Camp: Thorne Bay

Road: 5202, Sections I, II, III

FISH CULVERT SURVEY

ROAD # 5202

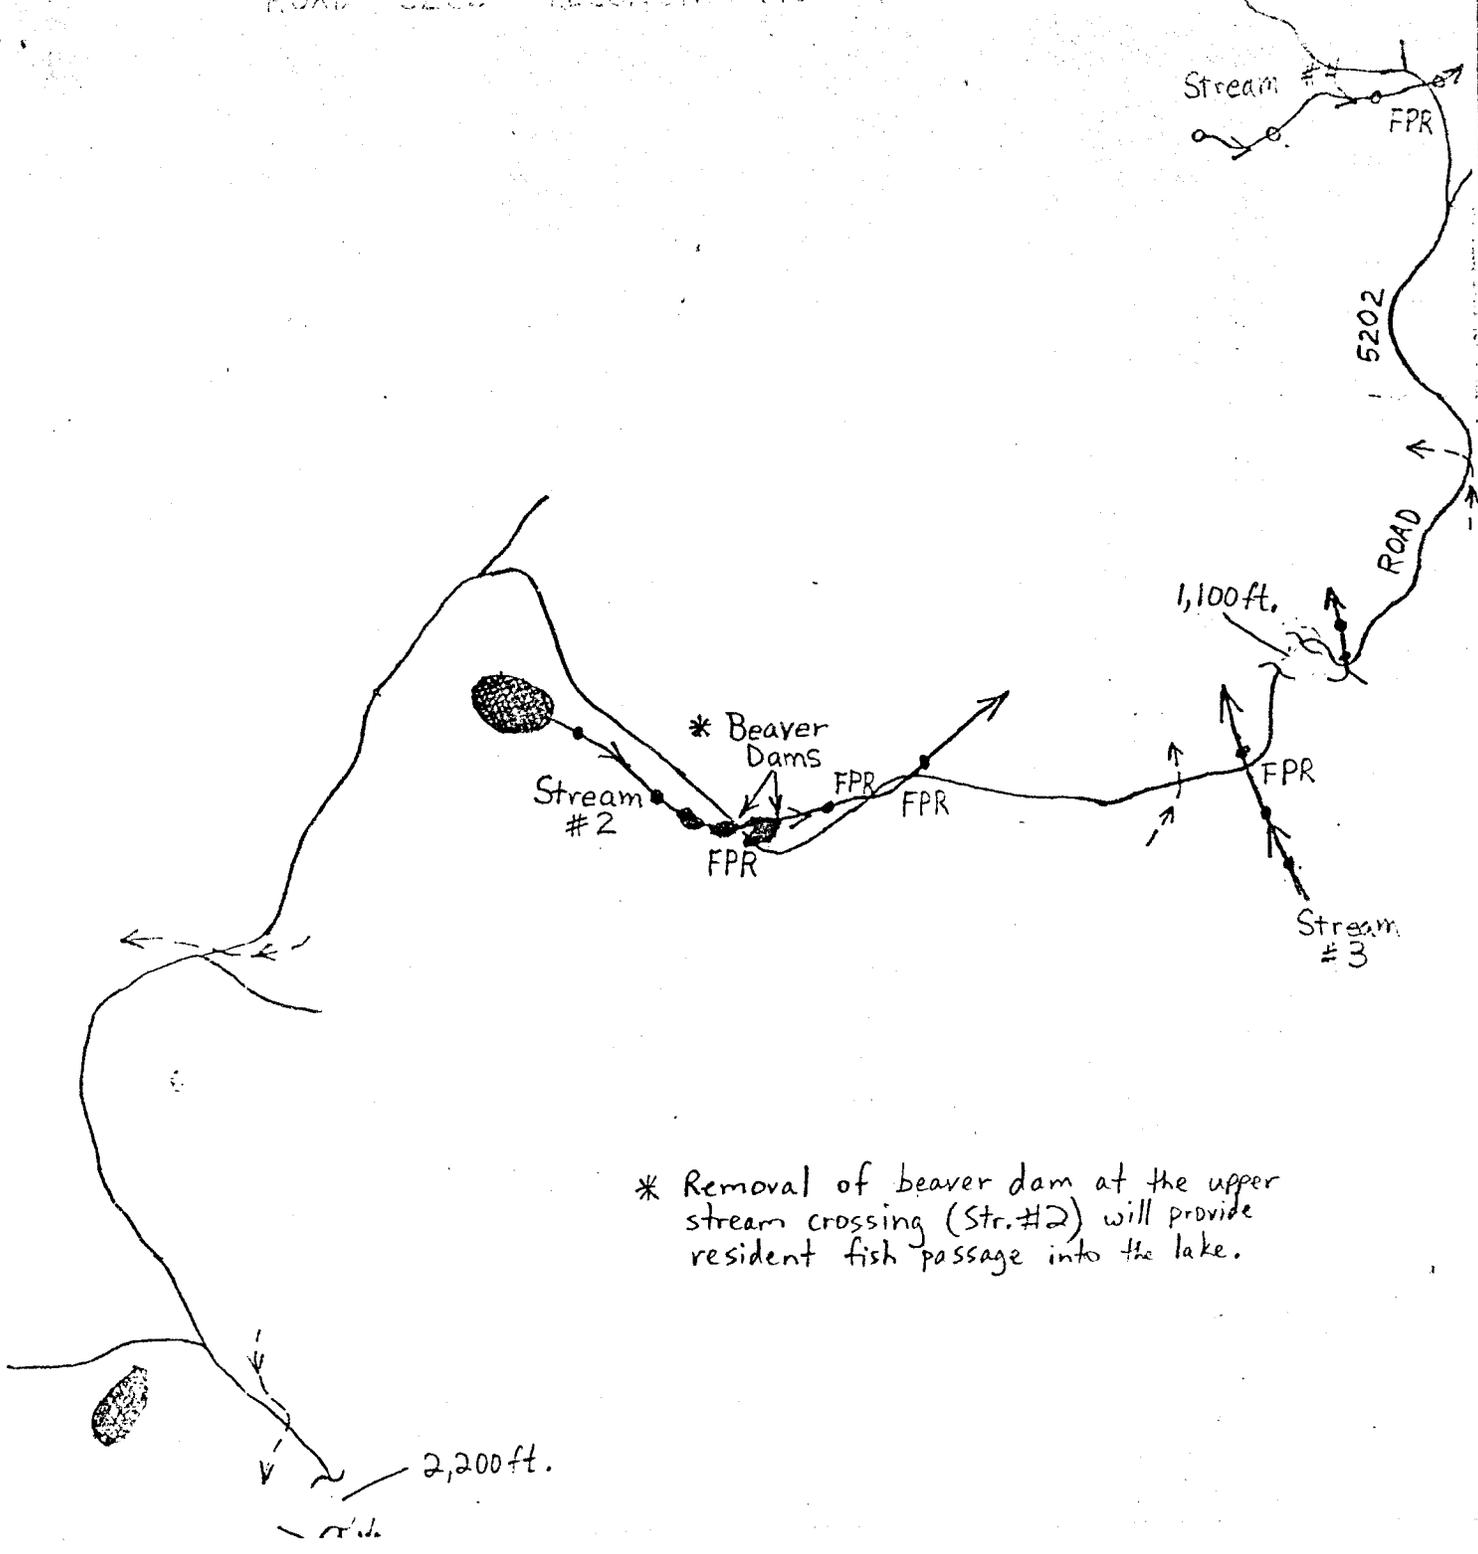
If so Describe: Remove old beaver dam where Road #5202 intersects beaver pond (see figure/map). This will allow resident fish passage where it is currently restricted.

Pertinent Wildlife Information: Abundant fresh bear sign; deer sign; several abandoned beaver dams; one active dam where Str. #2 crosses road.
 Comments: Stream #1 parallels Road #5202 for several thousand feet. The lower two stream crossings have partially collapsed bridges and will require repair. Str. #1 crosses the road 3 additional times and will require culvert installation for fish passage at each. Stream #2 will require culvert installation for fish passage at the upper stream crossing and at 2 lower crossings as shown on the map. Stream #4 will require a bridge crossing; the stream channel is $\approx 35'$ wide at the road crossing.

* Removal of beaver dam at the upper stream crossing (Str.#2) will provide resident fish passage into the lake.
